PRESSURE CAP ADJUSTMENTS

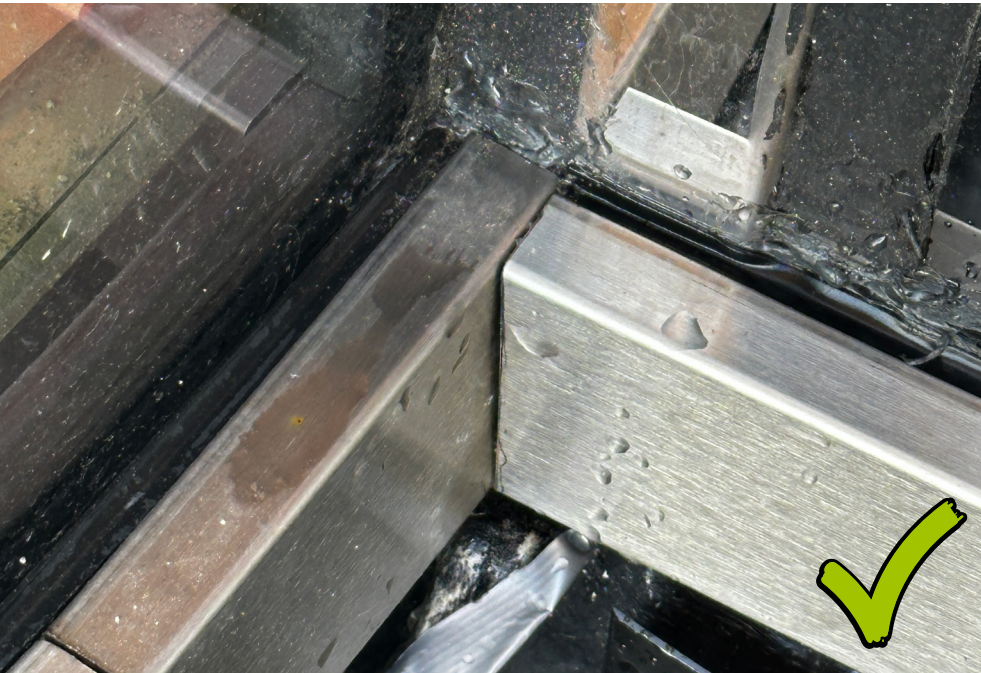
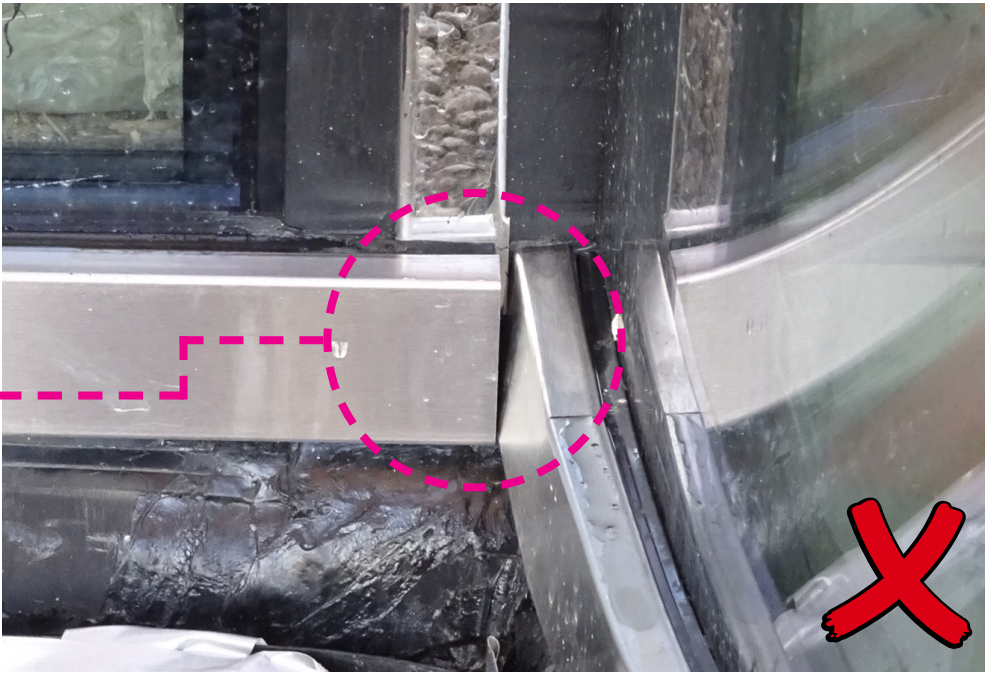
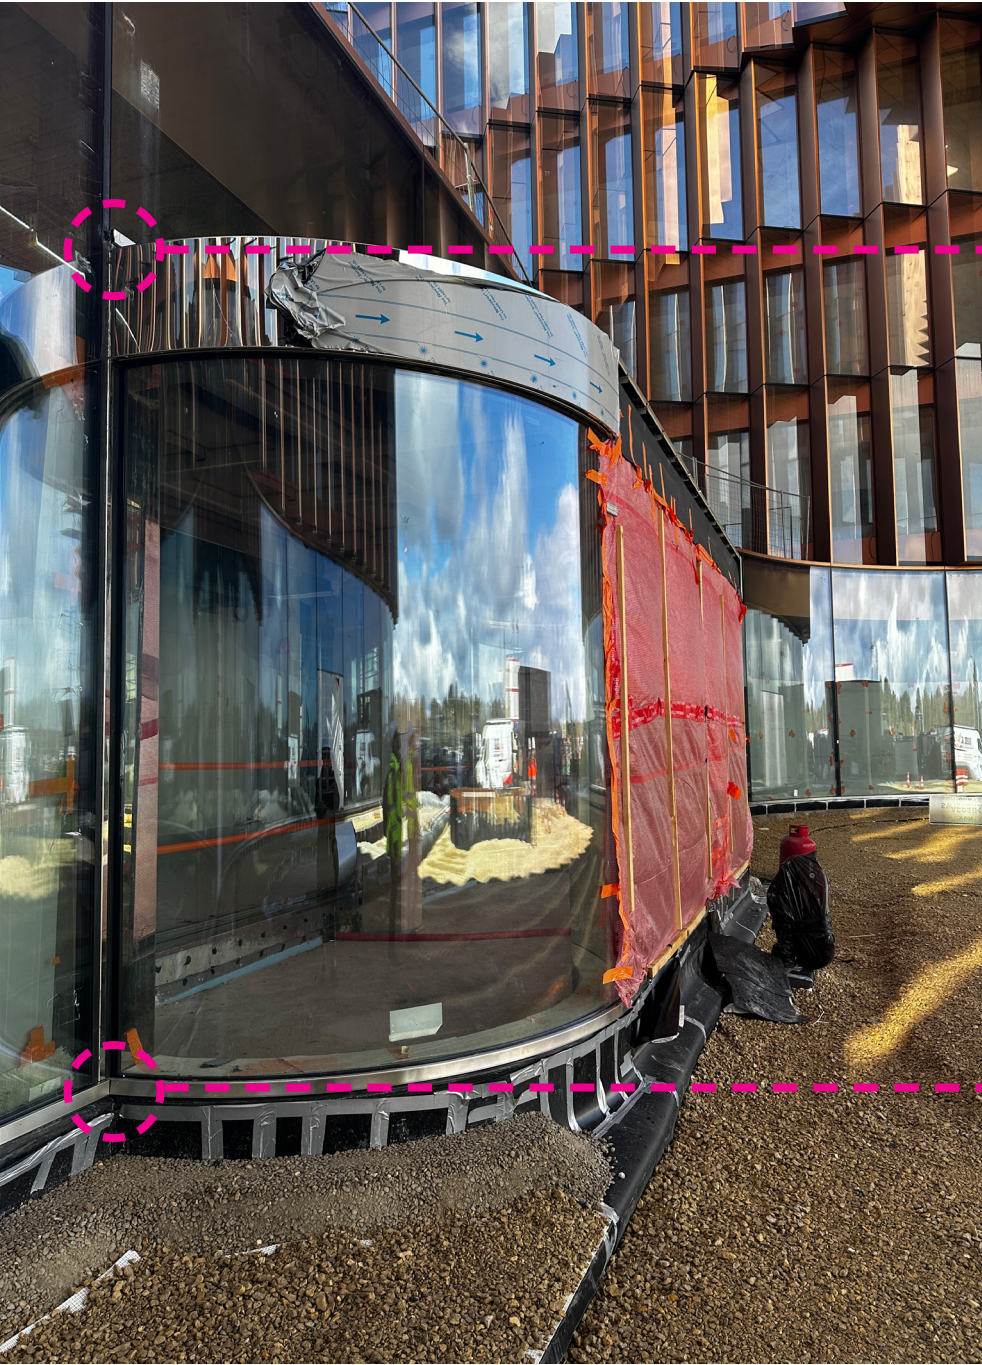
OBSERVATION:
- The pressure caps on the left side of the RDC airlock (top and bottom) are misaligned or broken, however; they are well executed on the right side.

RECOMMENDATION:
- Kyotec to adjust misalignments and replace damaged profiles.

VISIBLE SCREWS ON UNDERSIDE OF TOP PROFILE (INT.)

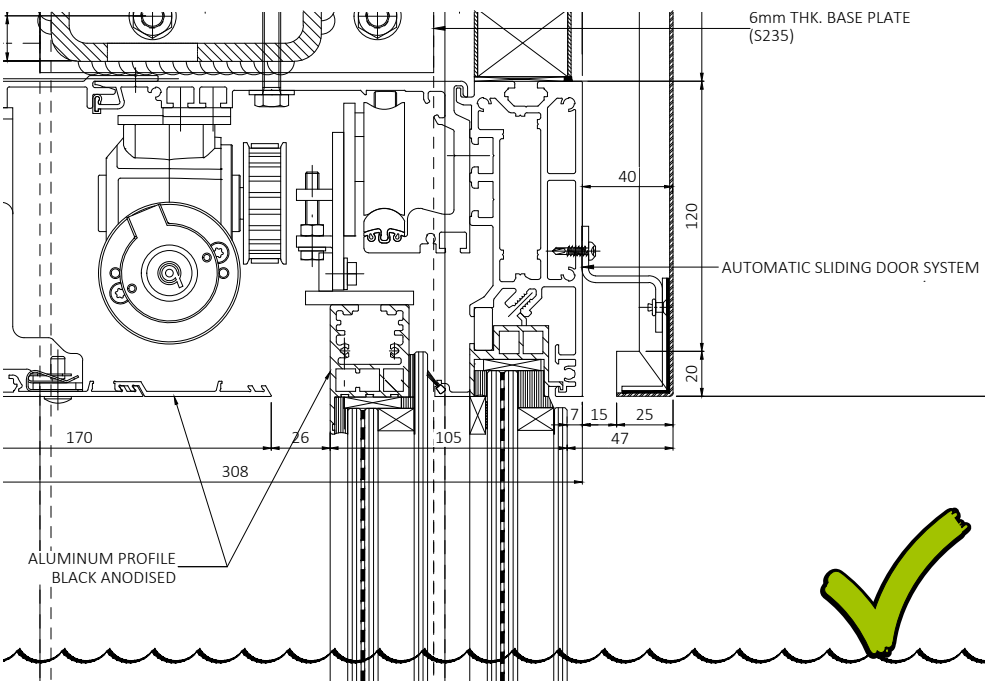
- The upper panel on the interior side of the RDC airlock has screws visible on the underside. This was not executed as per the last approved detail by BIG, which has all fasteners concealed internally.

- Kyotec to replace panels and execute the installation as per the last approved detail.

PANEL EXECUTION: JOINTS OF EDGE PANEL / SOFFIT

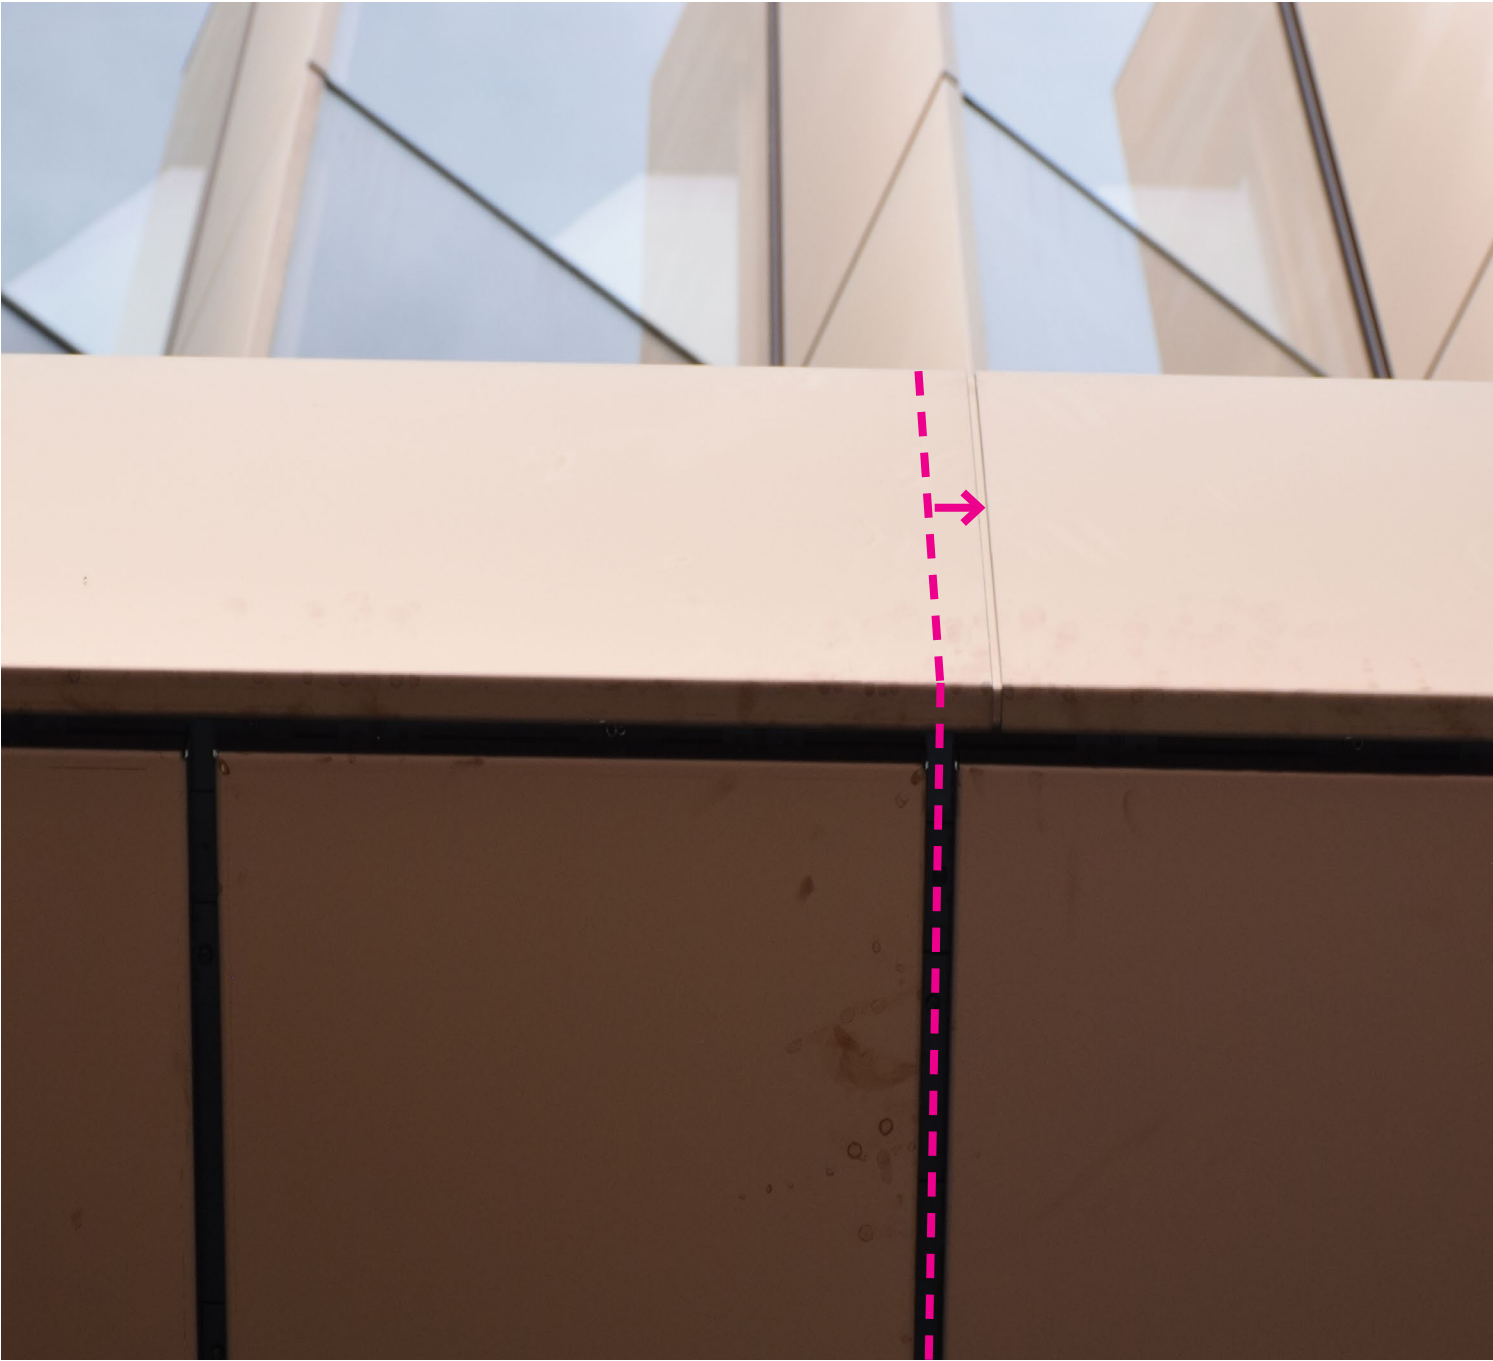
OBSERVATION:
- THE JOINTS BETWEEN THE EDGE PANELS AND THE SOFFIT ARE SLIGHTLY OFFSET AND MISALIGNED. THIS AGAIN SUPPORTS THE OBSERVATION THAT THE SOFFIT PANELS SHOULD BE SHIFTED TOWARD THE TERMINAL.

RECOMMENDATION:
- IF POSSIBLE, SHIFT THE SOFFIT PANELS TOWARDS THE TERMINAL. IF THE SHIFT IS NOT POSSIBLE, RE-CUT THE FRONT PANELS SO THAT THE JOINTS ARE ALIGNED WITH THOSE OF THE SOFFIT PANELS BELOW.

PANEL EXECUTION: GAP AT HOTEL SIDE

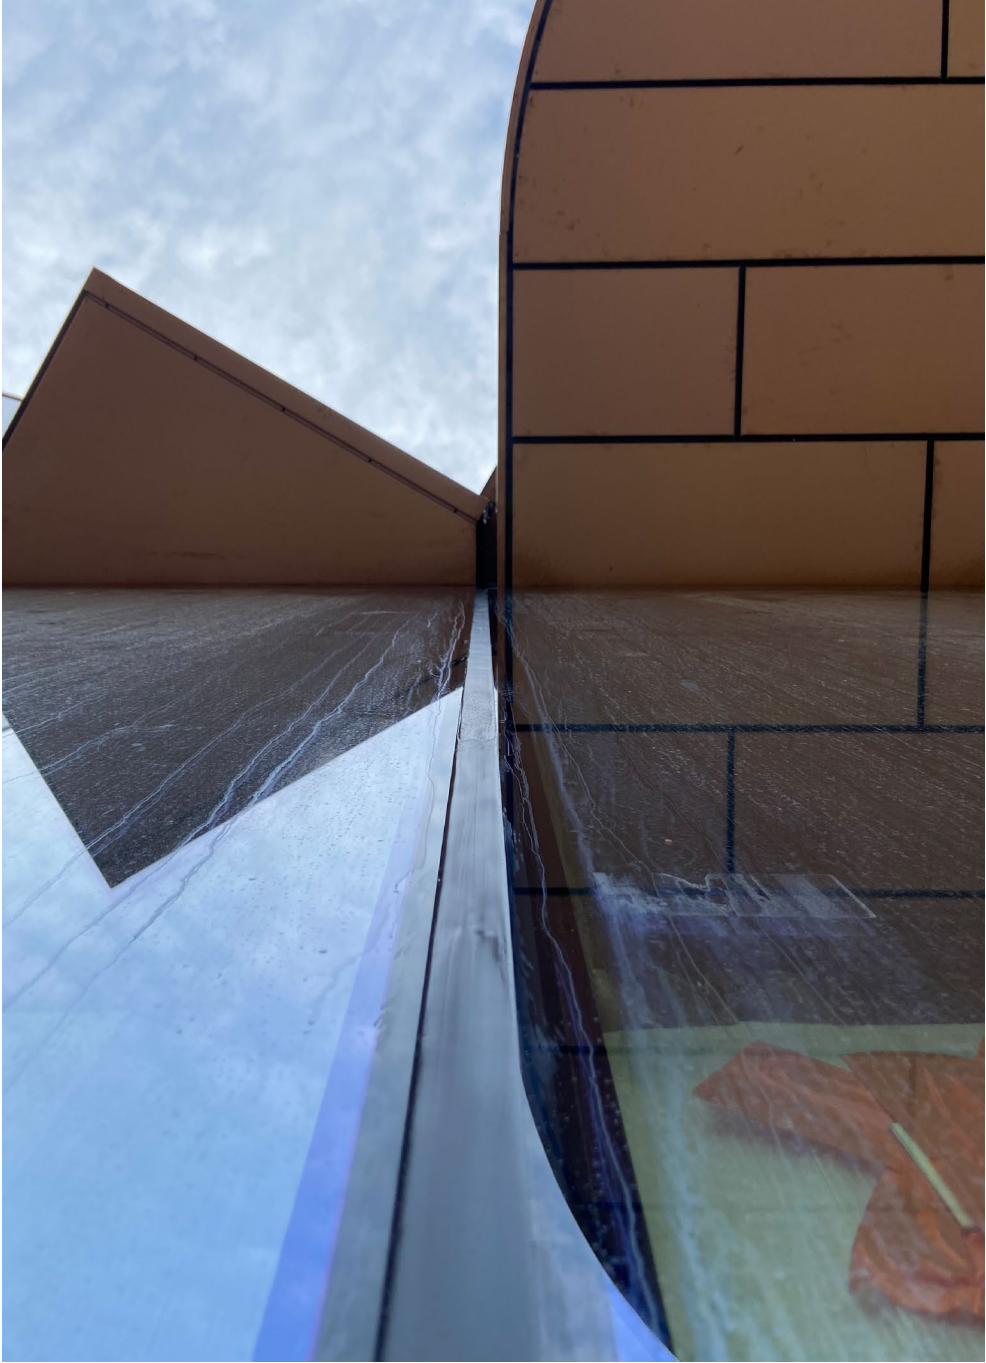
OBSERVATION:
- OVERALL EXECUTION HERE IS GREAT, HOWEVER; THE GAP ON THE BOTTOM SIDE LEAVES SOME OF THE SUBSTRUCTURE VISIBLE FROM BELOW.

THE SUBSTRUCTURE SHOULD BE CONCEALED HERE.

RECOMMENDATION:
- INSTALL A SMALL FLASHING OR SOMETHING BLACK (VERTICALLY ON TO THE STRUCTURE) TO MINIMIZE THE VISIBILITY OF THE GALVANIZED STRUCTURE.

PANEL EXECUTION: SECOND JOINT AT CURVE

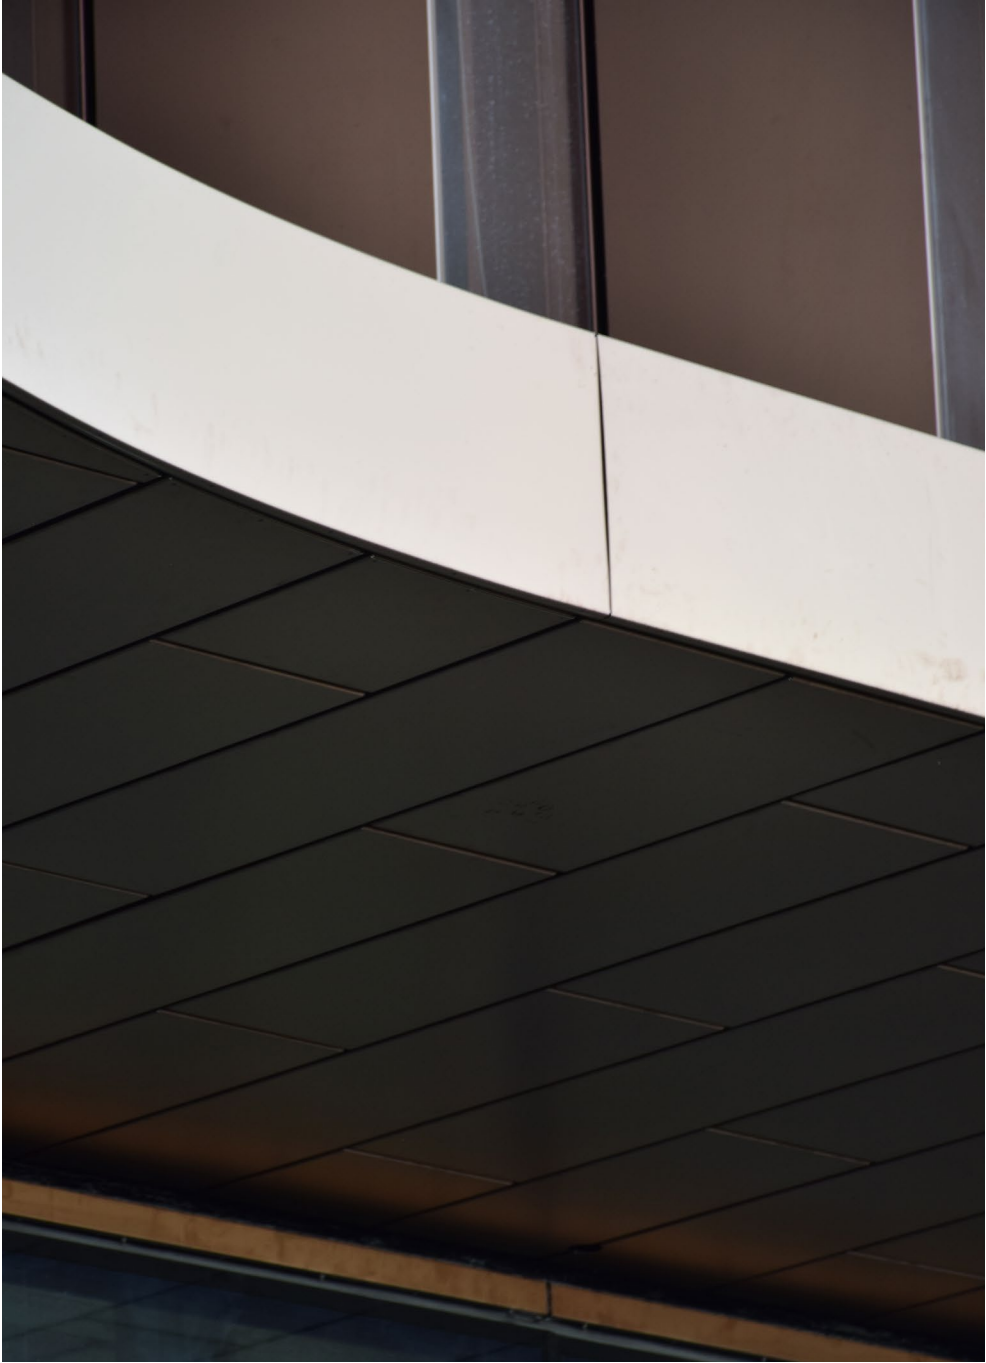
OBSERVATION:
- THE APPEARANCE OF THIS JOINT IS UNSATISFACTORY AND THE PANEL SEEMS TO BE DENTED OR WARPED, CREATING A GAP.

RECOMMENDATION:
- REPLACE OR ADJUST PANELS.
